Office Action Summary

09/410,952

NOLD ET AL.

Detailed Action

Reproduced from USPNO. 6,152,588

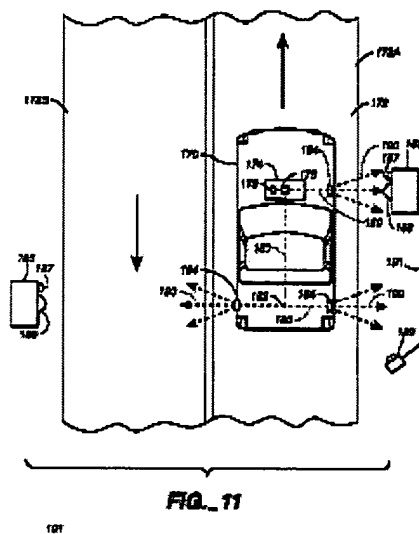
Claims 1 - 5, 8 -11, 13-14 and 16 are rejected under 35 U.S.C. 102(a) as being clearly anticipated by Scifres (USPNO.6, 152,588).

Figure 11 of Scifres (USPNO.6,152,588) discloses a vehicular lighting system comprising a semiconductor light sources or laser diodes (176) is optically coupled to a fiber optic waveguide. Fiber waveguides distally transmits the beams to the optical loads of the vehicle, including the brake lights, taillights, instrumentation lights and turn signals. Each fiber optical waveguide is a single optical fiber (180).

Coupler having a body and a plurality of lenslets (184) which is corresponding to a respective light source and each lenslet directing light through the body to the optical fiber and each lenslet directing light through the body to the optical fiber.

Reproduced from USPNO. 6,152,588

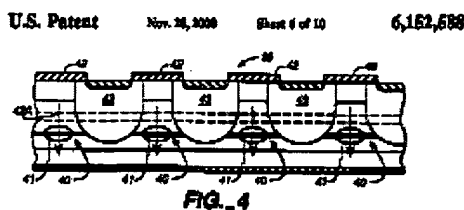
Regarding claims 2 & 11, body has sides with a predetermined angle with respect to a face of optical fiber as is shown in figure 11.

Regarding claim 4, the light sources comprise a wafer having a plurality of laser cavities clearly shown in the above figure 4.

Reproduced from USPNO. 6,152,588

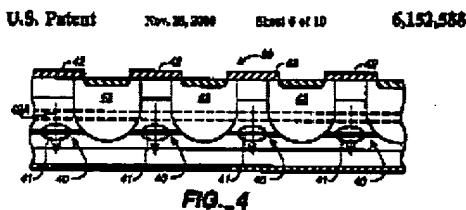
Regarding claim 6, wedge shape of the lenslets has an angle directing light to a face of said optical fiber mentioned in column 9, lines 45-52.

Scifres fails to mention regarding claims 7 & 15, wherein said angle increases as a distance from a center emitter increases. It would have been obvious to one of ordinary skill in the art at the time of the invention to use the teachings of Scifres since an important feature of the invention is that the beam, exiting from the output end of fiber 30B provides for sufficient diffusion of the coherent light so as to render it harmless when the beam is viewed with the naked eye beyond lens 133 and also it improves the safety of the source by reducing its brightness. For details see column 7, last paragraph.

Regarding claim 12, wherein said predetermined angle allows substantially total internal reflection of said light within said body shown in figure that a monolithic structure and lens and lens are directed at a predetermined angle which is 90 degree angle. For details see column 9, second paragraph.

Scifres reference fails to teach the teachings of total internal reflection of said light within said body. It would have been an obvious matter of design choice to arrange such internal reflection light within the body since, applicant has not disclosed that the criticality of using total internal reflection of light solves any stated problem or is for any particular purpose and its appears that the invention would perform equally well with any arrangement where total internal reflection of light is not even within the body.
